Thor Motor Coach Recall Repair Instructions

| Recall # | 19V-566 | | |
| Description/Title: | MORryde Battery Tray | | |
| Affected Product Line(s): | Certain MY 2019/2020 Magnitude & Omni motorhomes | | |

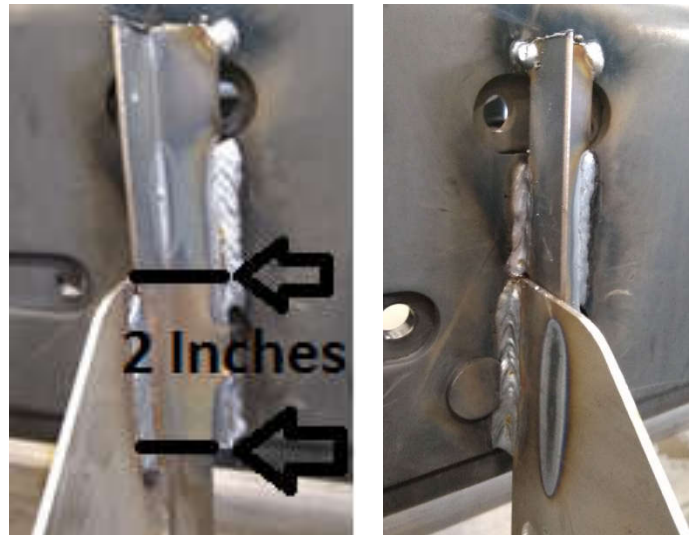
1. Open the hood and disconnect the positive and then the negative battery cables on both batteries. Once batteries have been disconnected, unclip all three harnesses on the electronic control module.

Before Repair

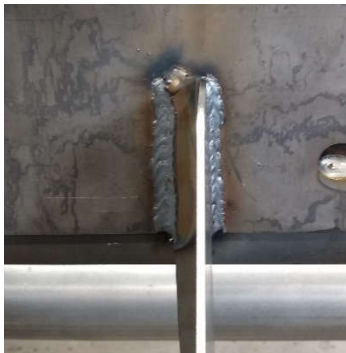
2. Locate the battery tray and disconnect both house batteries then wrap batteries, battery cables and fuse boxes with weld resistant blankets.
3. Weld one of the 1" X 1" angles to the inside or outside of each battery tray leg. The angle should be placed flush up against the side of the battery tray and flat up against the chassis. At least two inches of the angle should make contact to the battery tray to provide the required support. Weld all vertical seams available where the angle touches the battery tray or chassis rail. Do not weld on the chassis frame bend radius.

4. After work area has been able to cool, scrap off all burned off paint. Spray paint the newly installed angle, all welds and any areas where the original paint has burned off.
5. Remove all weld blankets, reconnect the electronic control module and both batteries.
